49 CFR Part 571

[Docket No. NHTSA-2003-15712]

Federal Motor Vehicle Safety Standards; Glazing Materials

ACTION: Final rule; response to petitions for reconsideration; correction.

Figure 1 — Test Fixture For Clamped Specimens

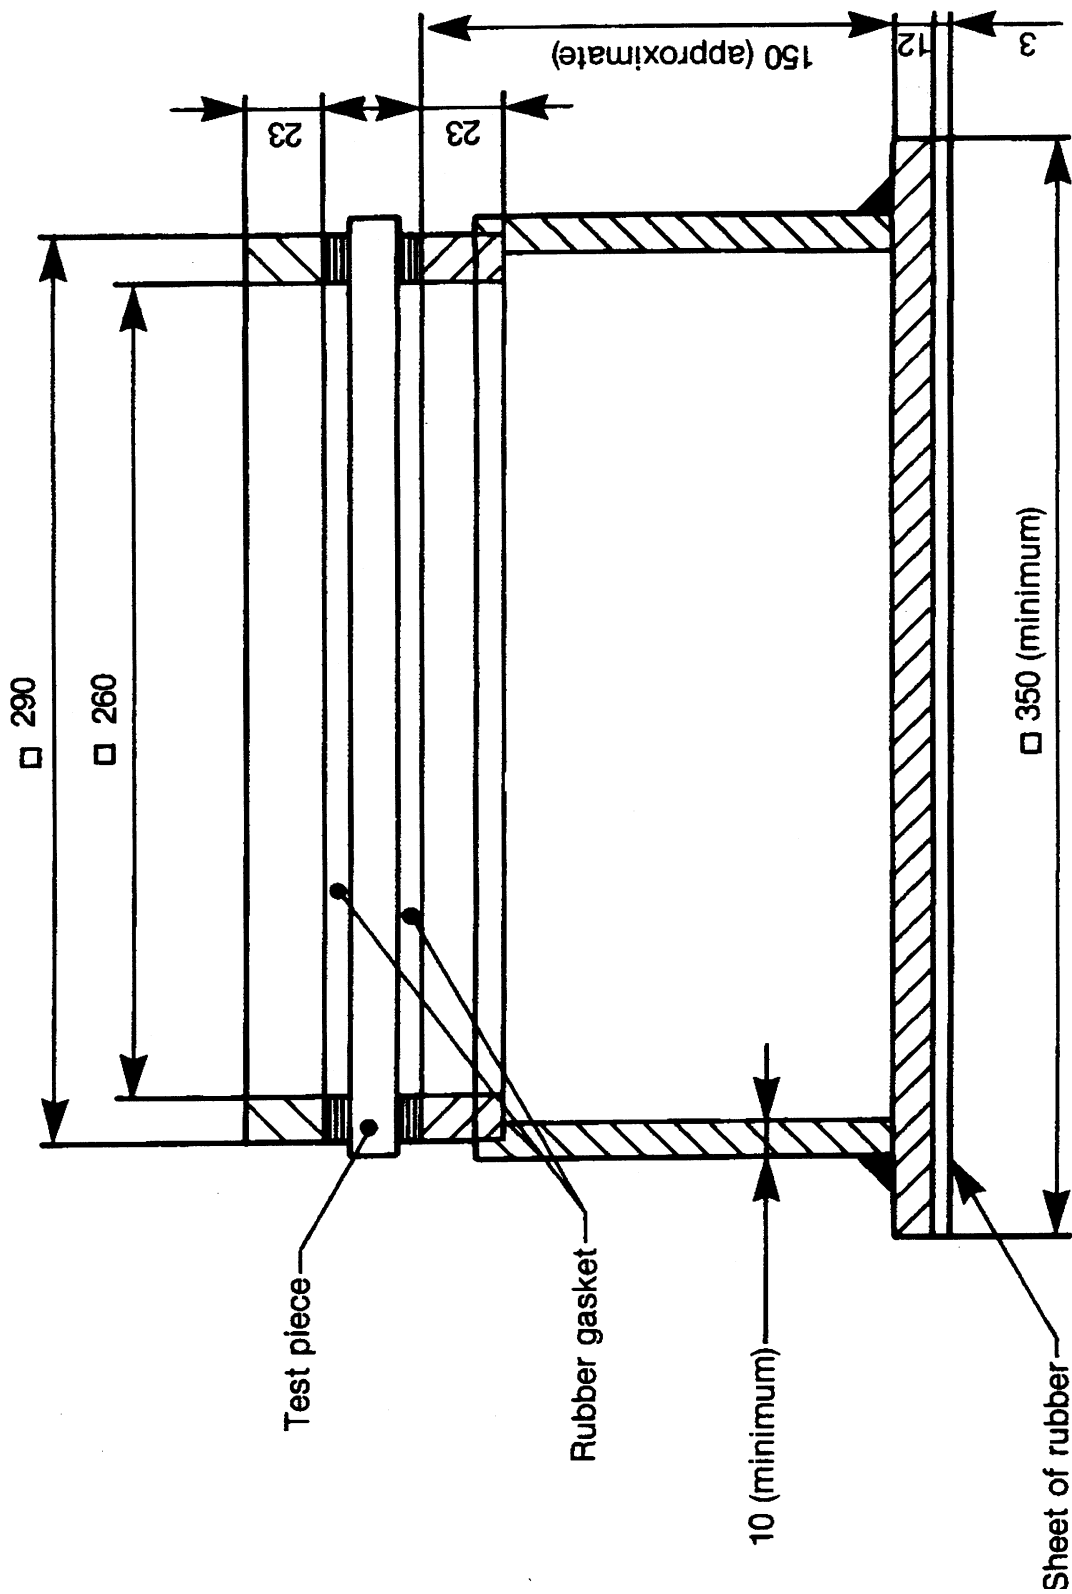
(e)(1) Except as provided in S5.1.2.9(e)(2), glass-plastic glazing specimens tested in accordance with Tests Nos. 9, 12, and 26 shall be clamped in the test fixture in Figure 1 of this standard in the manner shown in that figure. The clamping gasket shall be made of rubber 3 millimeters (mm) thick of hardness 50 IRHD (International Rubber Hardness Degrees), plus or minus five degrees. Movement of the test specimen, measured after the test, shall not exceed 2 mm at any point along the inside periphery of the fixture.

(2) At the option of the manufacturer, glass-plastic glazing specimens tested in accordance with Tests Nos. 9 and 12 may be tested unclamped. Such specimens shall be tested using the fixture in Figure 1 of the standard, including the upper frame (unclamped) which holds the specimen in place.
